HISTORIC AND DESIGN REVIEW COMMISSION

HDRC CASE NO: 2020-288
COMMON NAME: Comanche Lookout Park
ADDRESS: 15551 NACOGDOCHES RD
LEGAL DESCRIPTION: NCB 15832 BLK LOT P-4C
ZONING: R-6
CITY COUNCIL DIST.: 10
APPLICANT: Jordyn Patrias/City of San Antonio
OWNER: CITY OF SAN ANTONIO
TYPE OF WORK: Public art installation
APPLICATION RECEIVED: June 15, 2020
60-DAY REVIEW: Not applicable due to City Council Emergency Orders
CASE MANAGER: Rachel Rettaliata
REQUEST:

The applicant is requesting a Certificate of Appropriateness for approval to install public art at Comanche Lookout Park.

Comanche Lookout Park Public Art Opportunity Final Design Review

MONUMENT

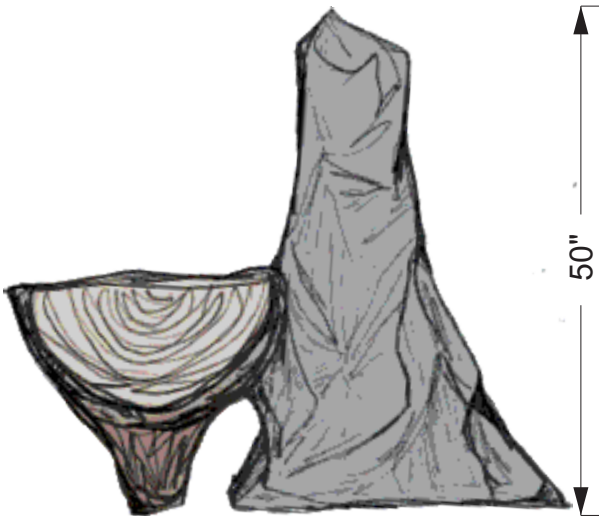
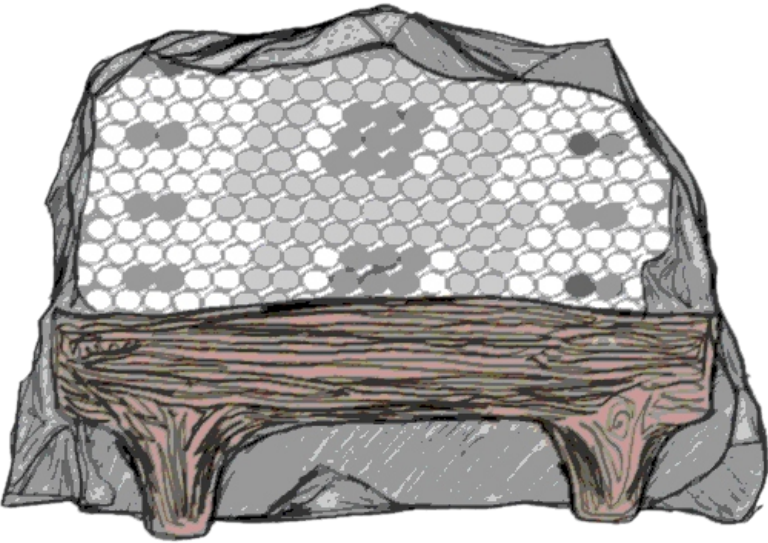
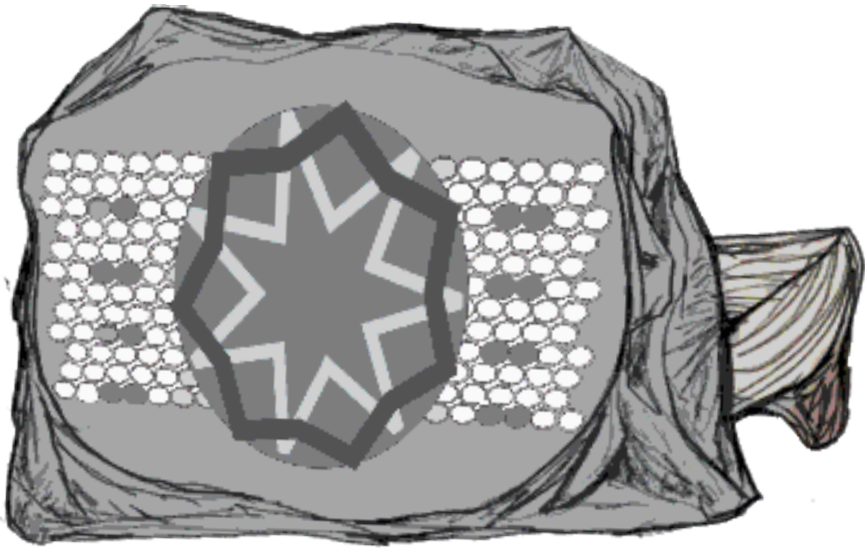
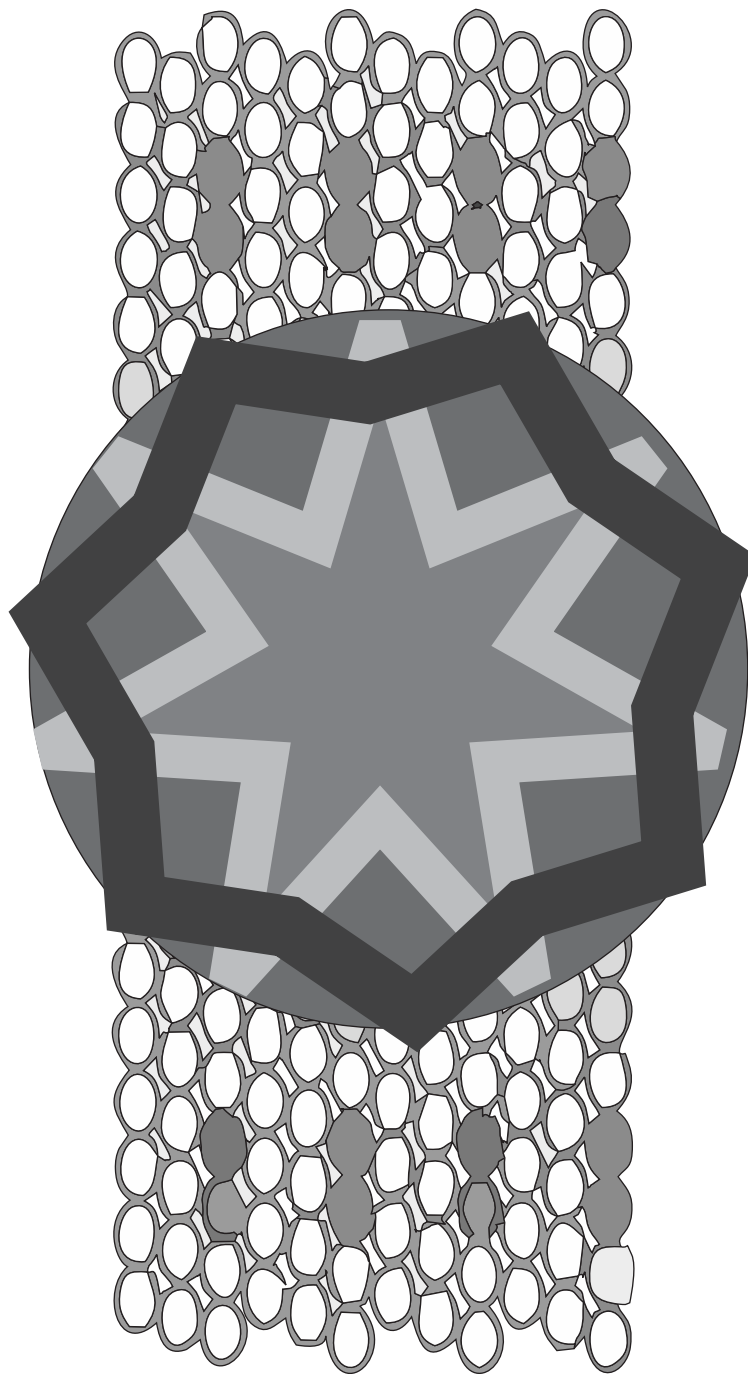
- d. PUBLIC ART: MONUMENT – The applicant has proposed a monument as part of the public art program. The monument will be created from reinforced concrete meant to look like stone. The base will be about 4 feet wide, 3 feet deep, and 7.9 feet tall. The monument will be surrounded by faux stone concrete with concrete fill for support. Staff finds the proposal consistent with the UDC.

SIDE BENCHES
(QTY 2)

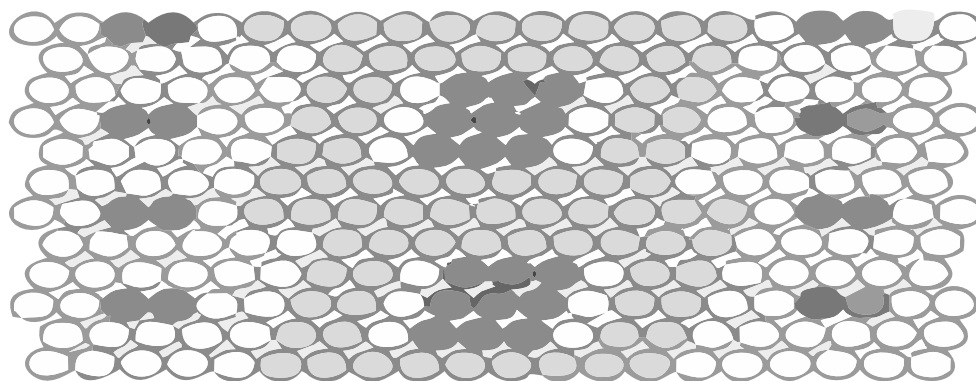
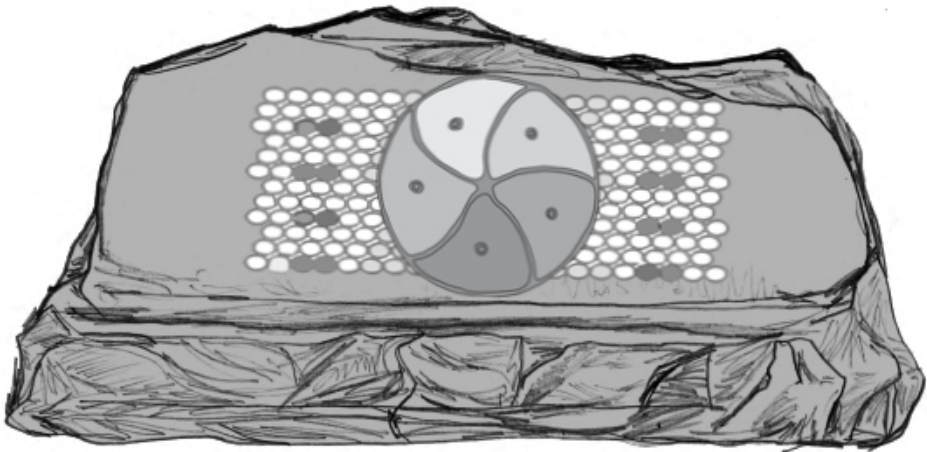
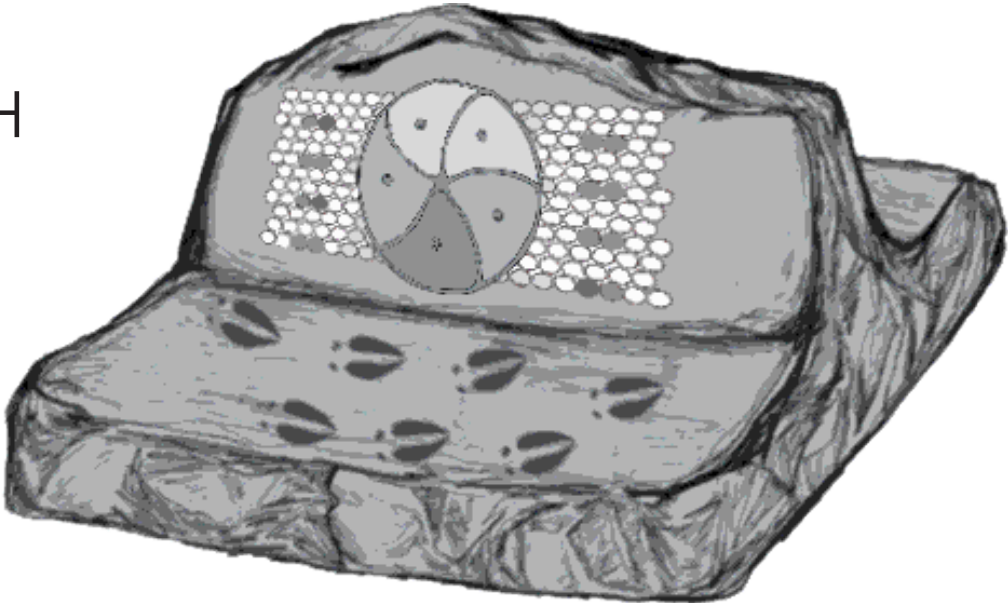
- b. PUBLIC ART: BENCHES – The applicant has proposed to install three (3) benches as part of the public art program. The two side benches will be made from reinforced concrete meant to look like stone and wood. The two side benches will be 5 feet long, 4 feet deep, and 4 feet tall. The central bench will be double sided and constructed from reinforced concrete made to look like stone. The bench will be 6 feet long, 6 feet wide, and 4 feet tall. The three benches will take the place of pre-existing benches on the site and will be set into a pre-existing concrete pad to mitigate any further archaeological disruption on the site. The benches meet the 3.5 feet clearance required for ADA accessibility. Both planters will be made from reinforced concrete. Staff finds the proposal appropriate.

PLANTERS

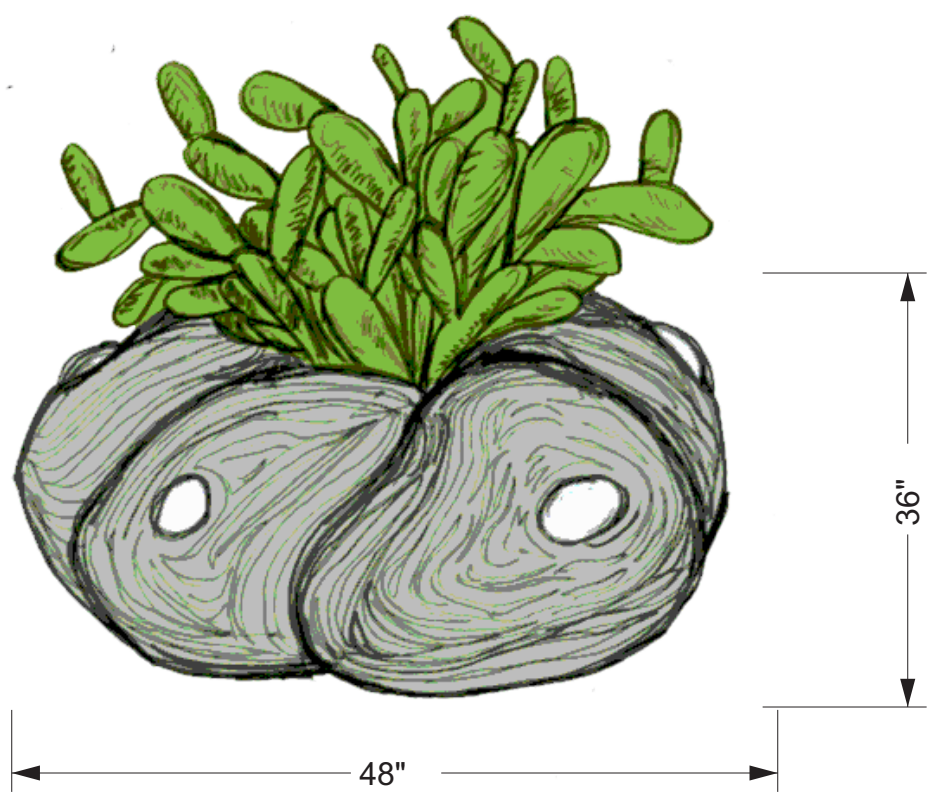
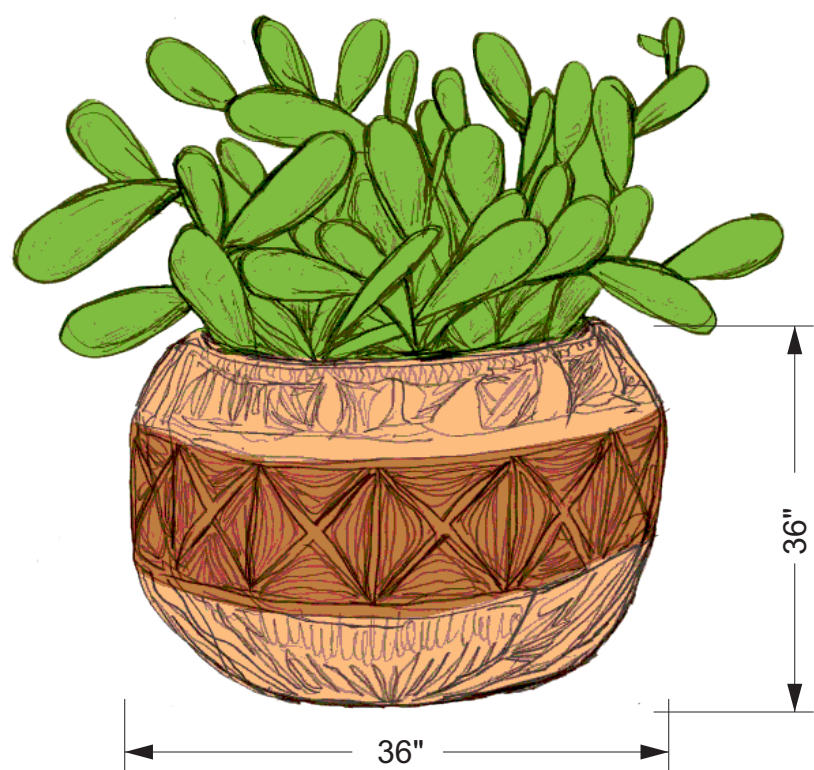
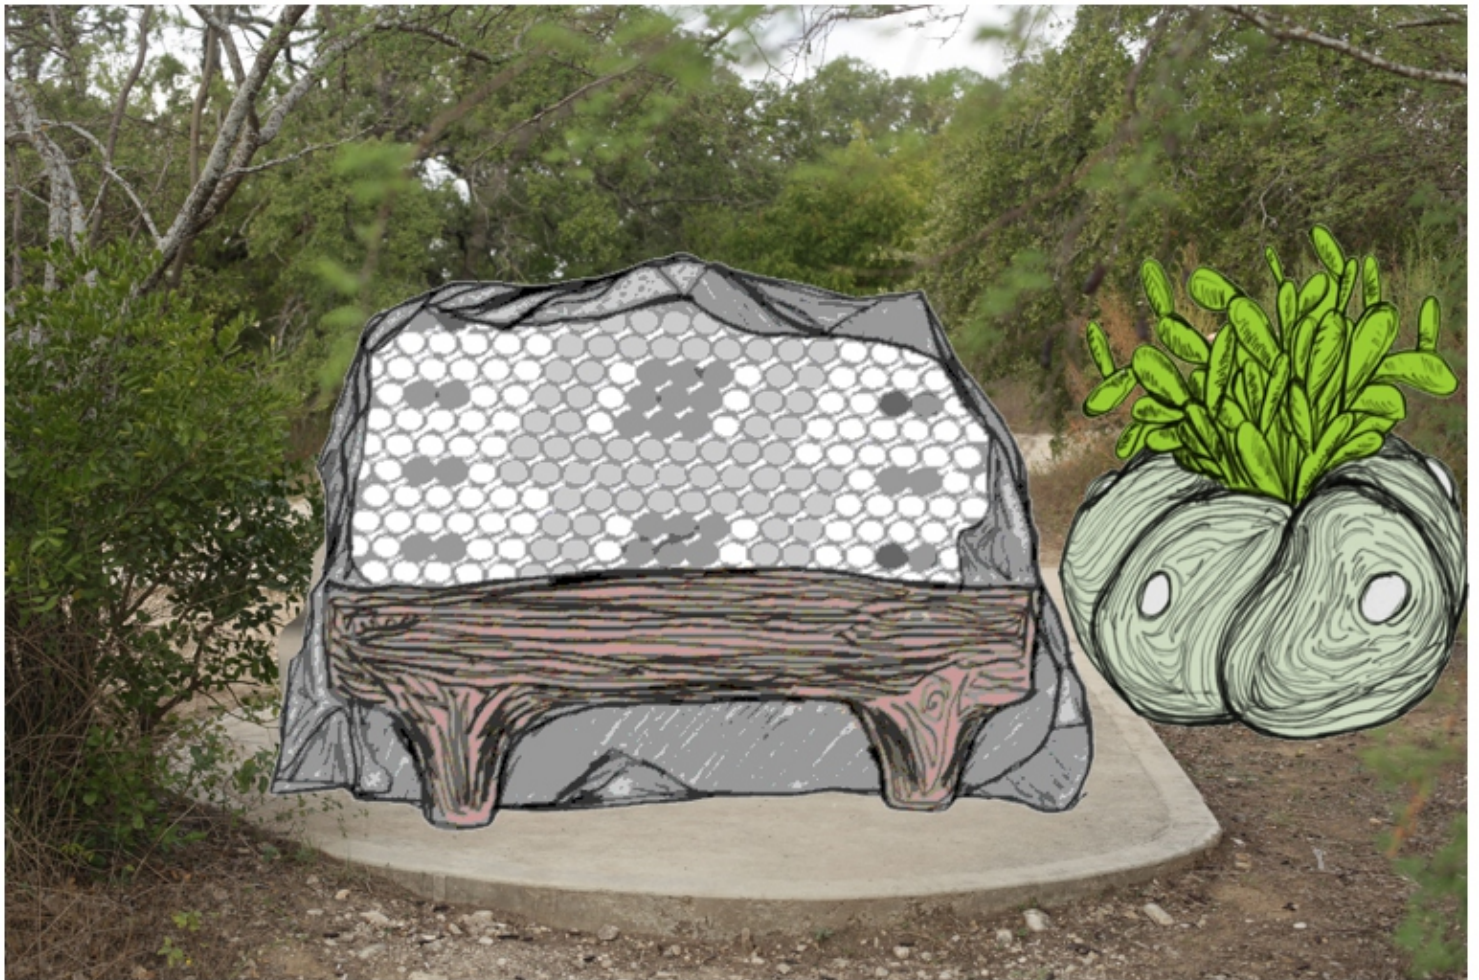
- c. PUBLIC ART: PLANTERS – The applicant has proposed to install planters as part of the public art program. The first planter is standard pottery shape and is proposed to be 3 feet wide and 3 feet tall. The second planter will be an abstract shape referencing the peyote cacti bud and is proposed at 4 feet wide and 3 feet tall. The planters will be placed on the soil next to each of the side benches. The artwork will feature integral coloring mixed with the concrete. They will feature a red/brown, green, and yellow-orange coloring. The coloring of all the artwork components will be natural and blend into the surrounding per the community engagement survey results. Staff finds the proposal generally consistent with the UDC.
